# Subregional RTEP Committee – Western FirstEnergy Supplemental Projects

November 20, 2020

# ATSI Transmission Zone M-3 Process Ayersville Weston Network and 69 kV Conversion Project

### ~~Richland-Weston~~ **Ayersville-Weston 69 kV Line - Conversion from 34.5 kV**

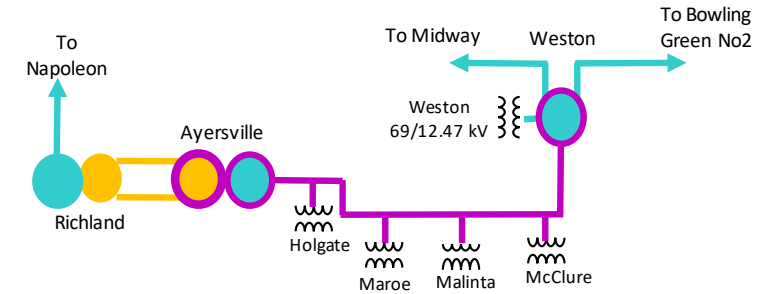
The scope change is driven by the challenges discovered for the constructability of the 69 kV line across the Maumee River to Richland substation. Additionally the scope of work to prevent a three-terminal line at the Weston Tap on the Bowling Green No2-Midway 69 kV line was not originally included.

- **Richland Substation:** Install one (1) new 69 kV breaker and reconfigure the 69 kV yard to a three (3) breaker ring bus with a new 69 kV line exit to Weston substation. Remove all 34.5 kV equipment post conversion (ex: Richland 138/34.5 kV transformer #1, circuit breakers, ... etc).

- **Ayersville Substation:** Install one (1) new 69 kV breaker. Install one (1) new 138 – 69 kV transformer. Install four (4) new 138 kV breakers and reconfigure the 138 kV yard to a four (4) breaker ring bus with a new 69 kV line exit to Weston substation. Close in the N.O. switch A13404 at Ayersville to network Ayersville 138 kV substation to Richland 138 kV K Bus. Remove all 34.5 kV equipment post conversion (ex: Richland 138 - 34.5 kV transformer #1 and circuit breakers).

- **Weston Substation:** Expand Weston substation to a four (4) breaker, future six (6) breaker ring bus with 69 kV line exits for the new ~~Richland~~ Ayersville line, and the Midway and Tontogany 69 kV lines. Remove all 34.5 kV equipment post conversion (ex: Weston 69/34.5 kV transformer #3, circuit breakers, ... etc).

- **Bowling Green No2-Midway 69 kV Line:**
  - Rebuild 5.0 miles of 69 kV transmission line from Weston substation to the Weston tap on the Bowling Green No2-Midway 69 kV line as double circuit to eliminate the three-terminal line from Weston, Midway and Bowling Green No2

- **New Richland Ayersville-Weston 69 kV Line:**
  - Build new 5.6 miles 69 kV line to network Richland Ayersville-Maroe and Weston-Malinta radial lines.

- ~~Richland~~ Ayersville-Weston 69 kV Line
  - After Proposed Solution: ~~80~~ 111 MVA SN / ~~96~~ 134 MVA SE
  - After Proposed Solution: 125 MVA WN / 159 MVA WE
